Rising Fashions Ltd.

Plot 16, Block-k, Rupnagar I/A, Mirpur-2, Dhaka-1216

17 September 2013

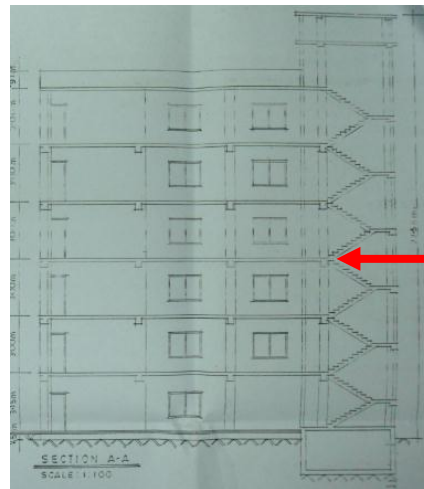
Column grid and column sizes agree with structural drawings

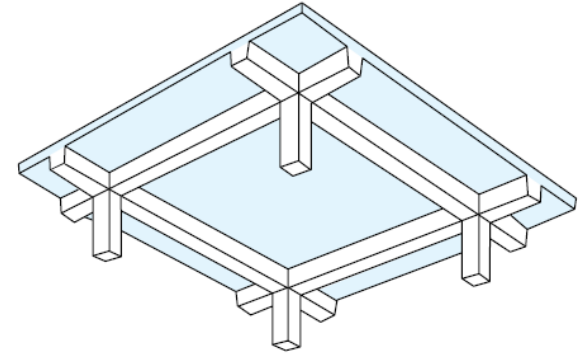
Permit Drawing for six floor agrees with observed building. No extensions. No refurbishment

Structural System
Solid slab with beams.
Column grid 5.05 x 4.77 m
Imposed design load
3.0kN/m²

Loads in Bonded/Storage areas

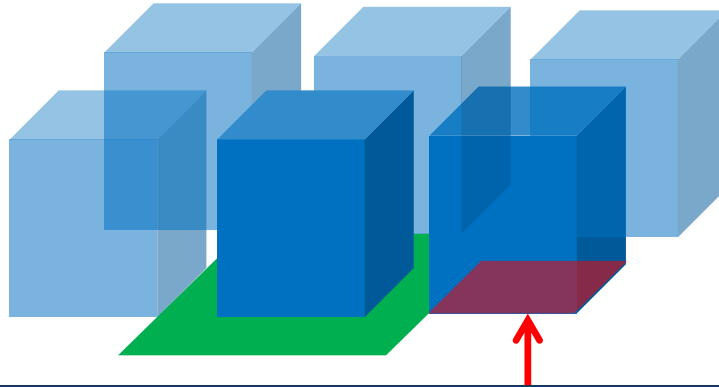
Super imposed design load 3.0 kN/m^2

Stacks ($1.50 \times 1.50 \times 1.80 \text{ m}$ high) produce an equivalent load of 6.0 kN/m^2
Keeping 0.50 m cleared strip all sides, equivalent area load 3.0 kN/m^2

ITEM 4: Control loading in Bonded/Storage areas.
